REMEDIATION SYSTEM EVALUATION

RISDON CORPORATION
DANBURY, CONNECTICUT

Report of the Remediation System Evaluation,
Site Visit Conducted at the Risdon Corporation Site
January 15, 2003

EPA 542-F-04-027
September 2004
www.epa.gov/tio
clu-in.org/optimization

FIGURE 1-3. EXTENT OF VOC CONTAMINATION BASED ON THE SEPTEMBER 2001 SAMPLING EVENT AND THE 2002 OFF-PROPERTY SOIL VAPOR AND GROUNDWATER SAMPLING REPORT. THE ORIENTATION OF CROSS-SECTION A-A' IN FIGURE 1-2 IS DEPICTED.

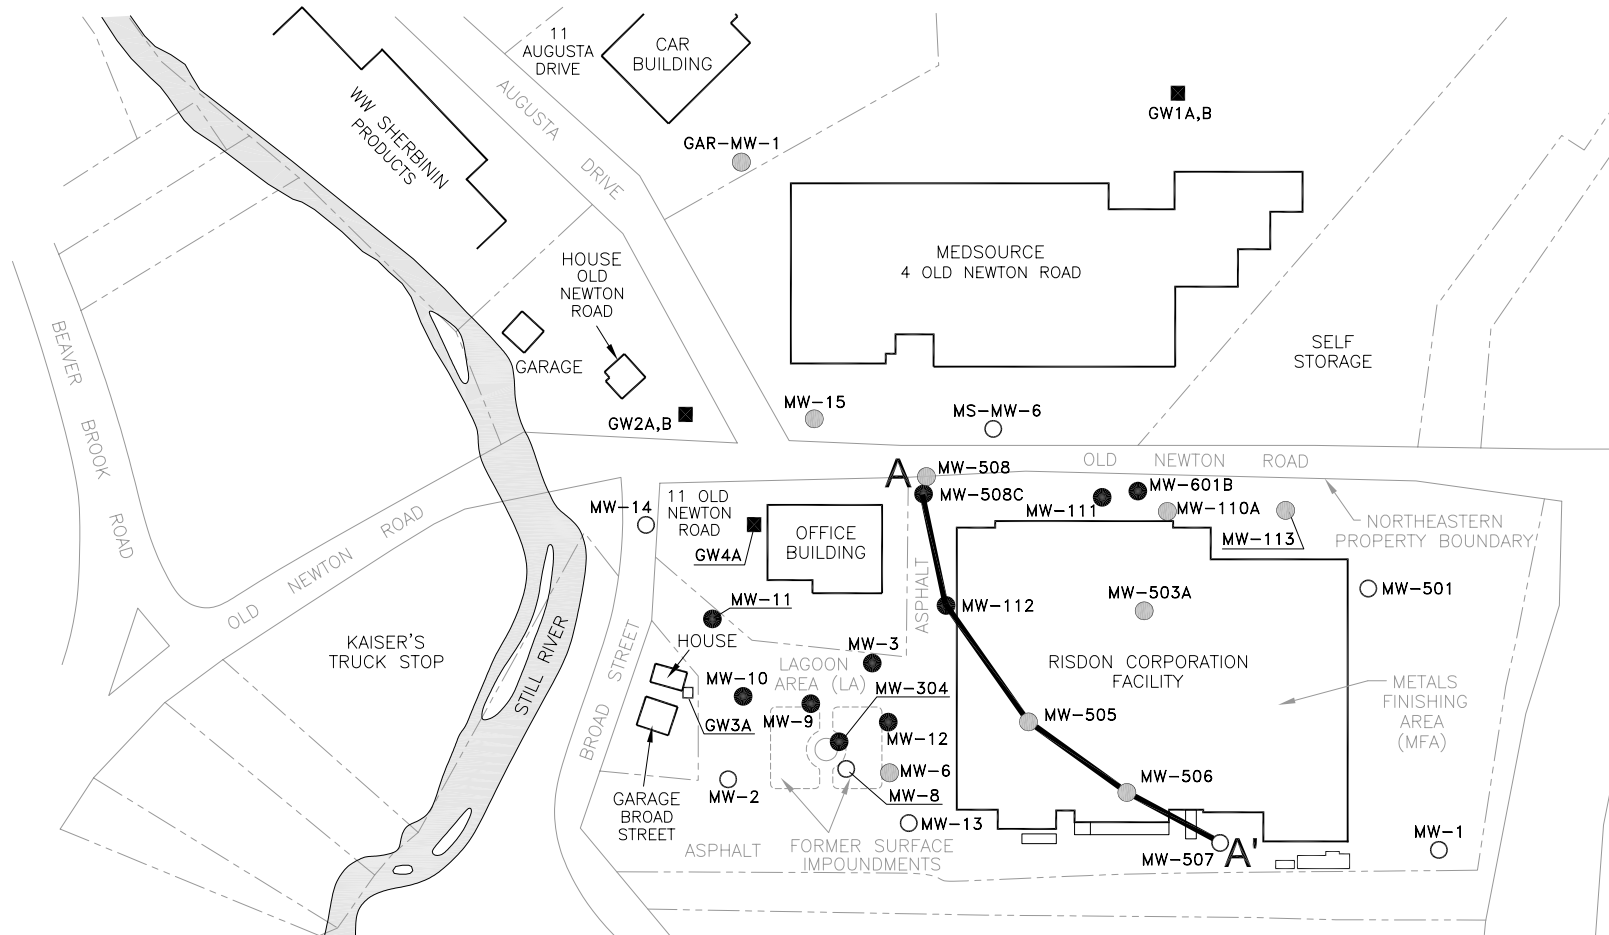
information with regard to the extent of the bedrock contamination found in MW-508C. The majority of the existing offsite monitoring wells are depicted in Figure 1-3.

FIGURE 4-1. POTENTIOMETRIC SURFACE MAP PROVIDED IN THE JANUARY 2003 GROUNDWATER MONITORING REPORT.

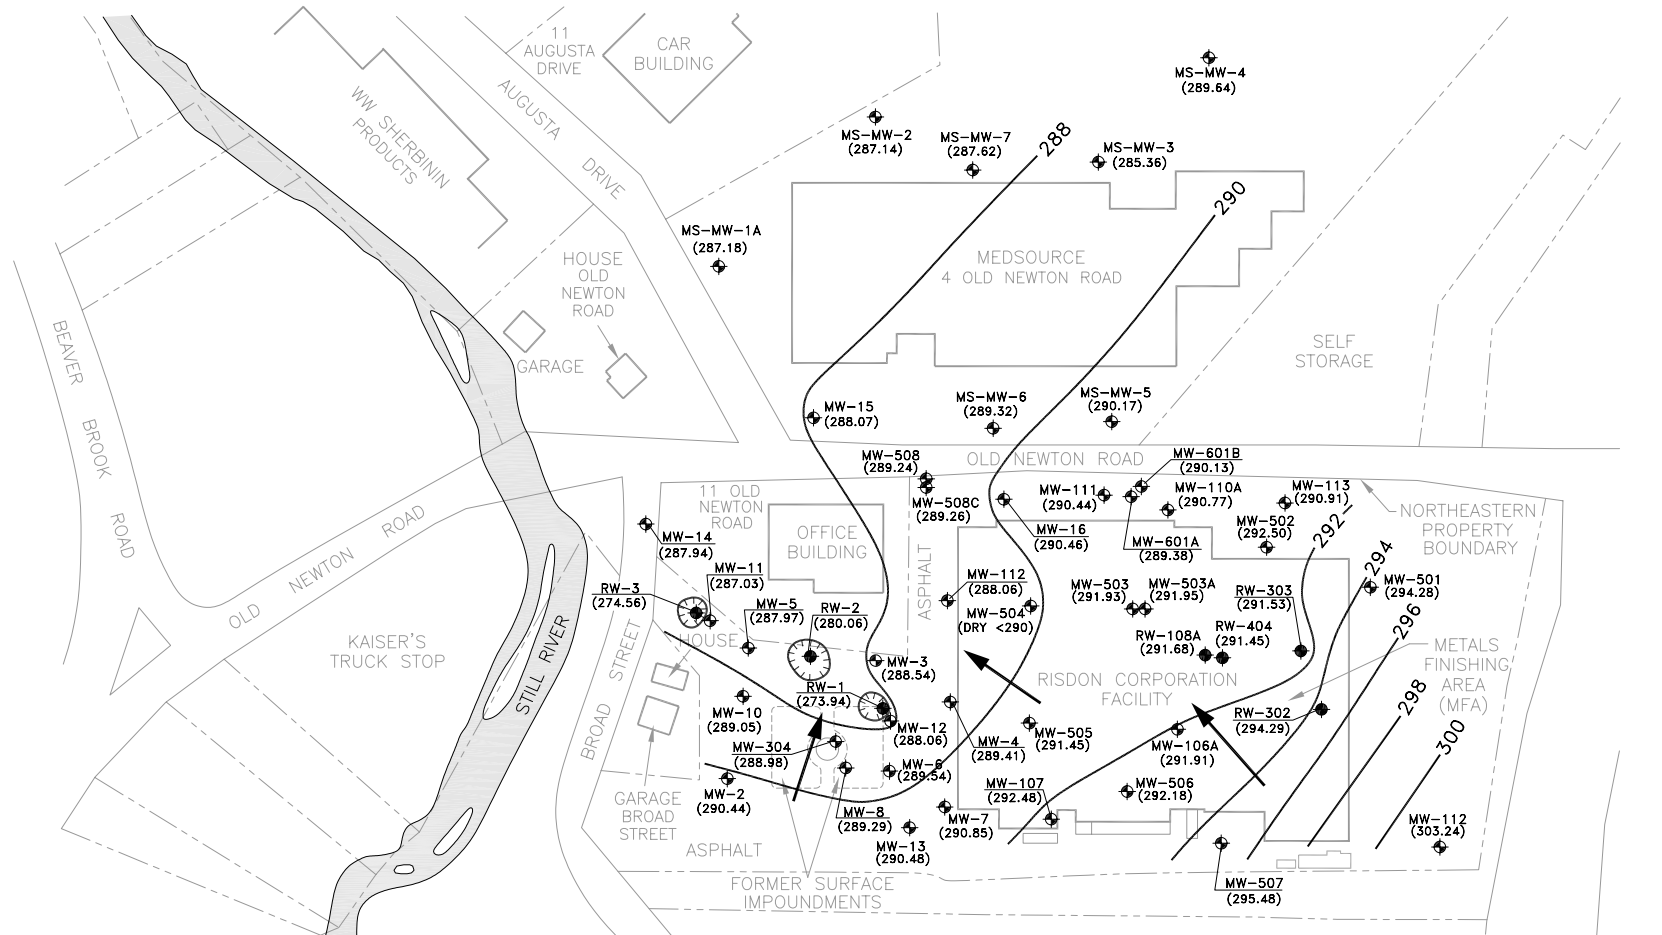
Ground water levels are collected and interpreted with each monitoring event. The potentiometric surface map presented in the January 2003 Ground Water Monitoring Report is included as Figure 4-1. It shows what appears to be influence of both P&T systems on the regional ground water flow. For example, the map shows that the regional gradient flattens in the MFA where extraction is occurring and cones of depression near each of the LA extraction wells. The contours, however, are influenced by the water elevations measured from operating extraction wells. Because extraction wells are subject to well losses and have very localized drawdown due to pumping, water levels from these wells are not necessarily indicative of the water level in the surrounding formation. As a result, if other water level measurements are not made in the area, some of the contours may show excessive influence due to pumping and perhaps an overestimated interpretation of plume capture. Specific examples of where the contours may overestimate the influence of pumping are as follows:

The monitoring report also does not provide the extraction rates for the various wells. Although extraction rates for the LA wells were originally 3 gpm each for a total of 9 gpm, the pumping has likely changed. In 1996, the total extraction rate was estimated at 3.5 gpm, and during the RSE site visit the flow totalizers for these wells revealed a total pumping rate of approximately 4.5 gpm, with RW-3 not operating. To better resolve the influence of pumping on the regional hydraulic gradient, the pumping rates should be provided along with the potentiometric surface maps, when possible.

FIGURE 6-1. RECOMMENDED LOCATIONS FOR ADDITIONAL EXTRACTION WELLS.

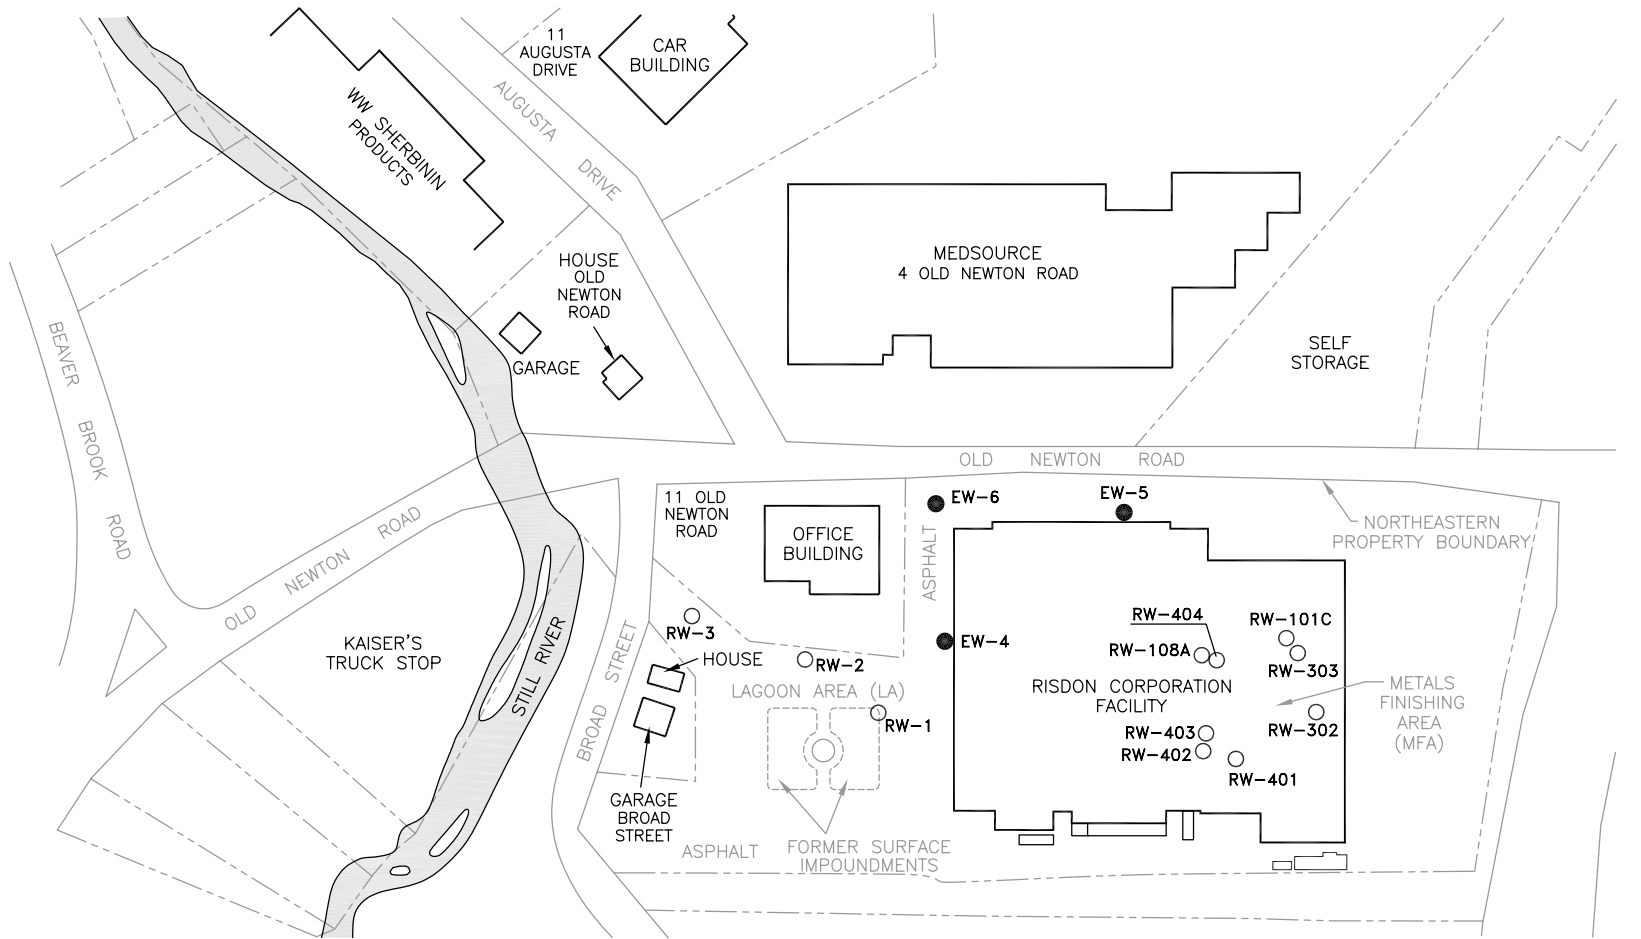
6.1.3 ADD EXTRACTION WELLS TO PROVIDE HYDRAULIC CONTAINMENT NEAR THE PROPERTY BOUNDARY

- It should work in concert with pumping from the LA to prevent offsite migration of contamination in both the overburden and the bedrock (i.e., stabilize the site).
- It should provide a zone of capture that, if possible, does not include receptors. That is, the extraction wells should be located such that contamination is not pulled near potential receptors at levels that pose an unacceptable risk.

Submersible pumps should be used at the new wells because they allow for drawdown beyond ~27 feet (~80% of a perfect vacuum), which is the maximum the aboveground pumps can draw. The extra drawdown may or may not be necessary but in case it is, submersible pumps can provide it for a cost similar to aboveground pumps. The facility might also potentially save cost on smaller vault construction by using submersible pumps.
